Service Bulletin

Bulletin No.: PIP6132

Subject: Engine Oil leak between Engine Oil Pan to Oil Cooler Adapter

Brand:	Model:	Model Year:		VIN:		Engine:	Transmission:
		from	to	from	to		
Chevrolet	Corvette	2027		All	All	6.7L LS6	All

7216050

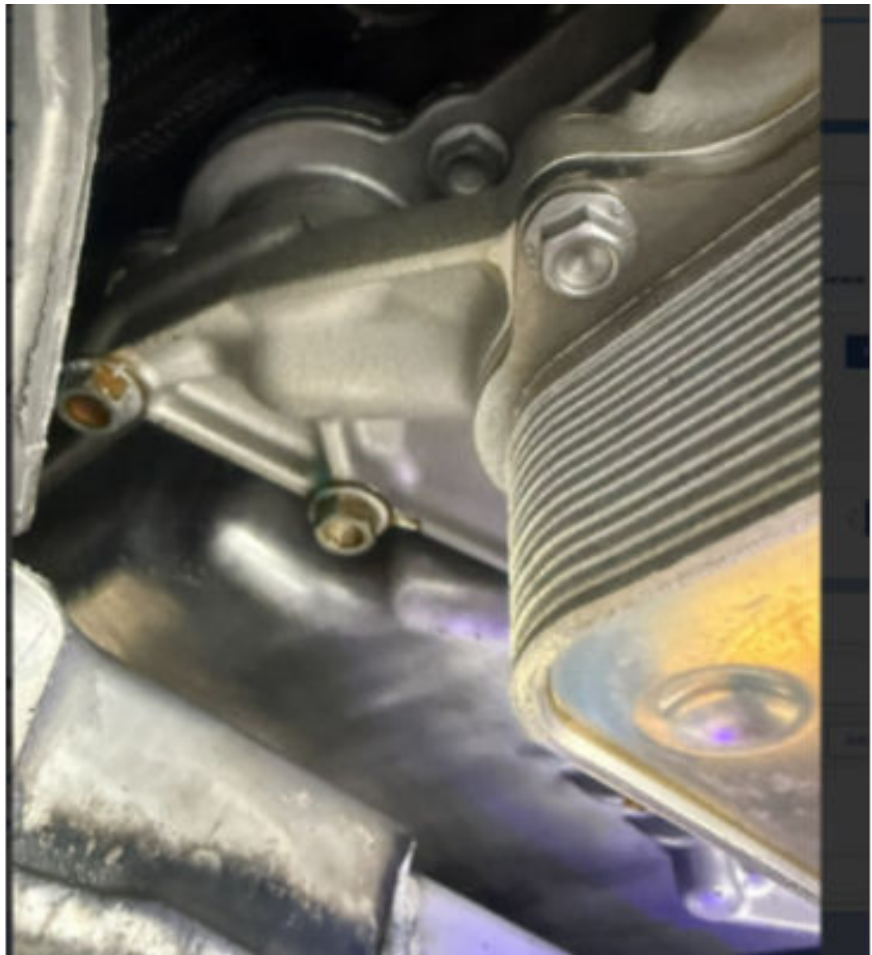
Involved Region or Country	North America
Condition	Some customers or technicians may notice that there is an engine oil leak visible from underneath the vehicle. During inspection, technicians may notice that there is a small oil leak that can be observed coming from between the oil pan and the oil cooler adapter.
Cause	When the engine is running this can also cause some bubbling in this area as well. When the engine is running this can also cause some bubbling in this area as well. This can be seen in the front mounting location of the oil cooler adapter or rear mounting area.

7216102

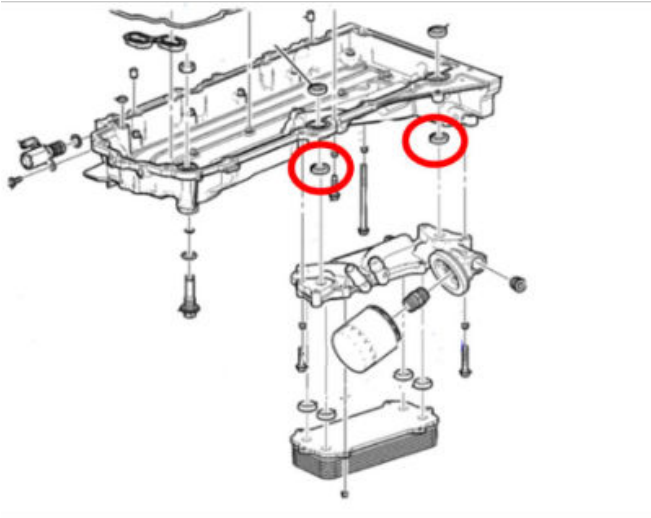
To correct this condition, it will be necessary to replace the 2 oil cooler adapter seals circled in the picture below:

Important: It is not necessary to separate the oil cooler from the oil cooler adapter as shown in the service information procedure.

7216054

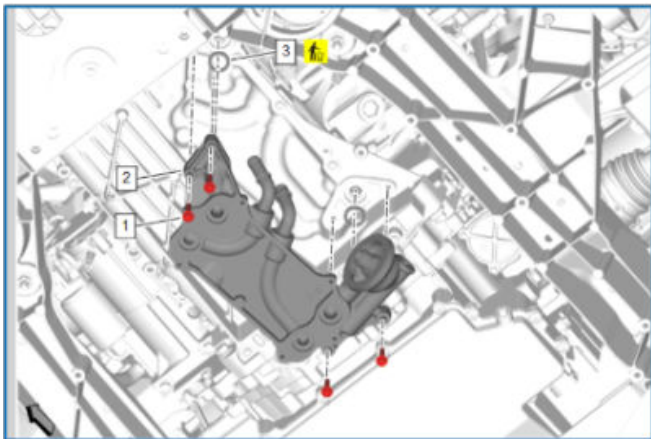
Important: To prevent any potential leaks when installing the oil cooler adapter bolts (1) it is very important to run the bolts down evenly and tighten in sequence, Refer to service information for specific torque procedure. The torque procedure is also noted below.

7216055

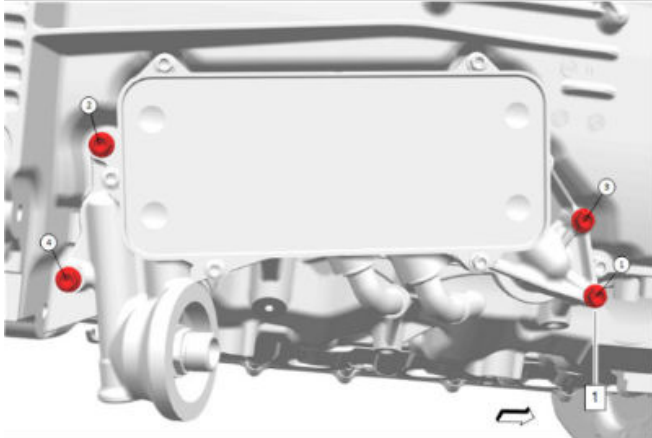
1. Oil Pan High Pressure Port Seal (3) Install NEW [2x]

2. Engine Oil Cooler Adapter (2) Install

3. Engine Oil Cooler Adapter Bolt (1) Install and tighten in sequence [4x]

Engine oil cooler adapter bolt torquing sequence:

First Pass: 5 Nm (44 lb in)

Final Pass: 15 Nm (11 lb ft)
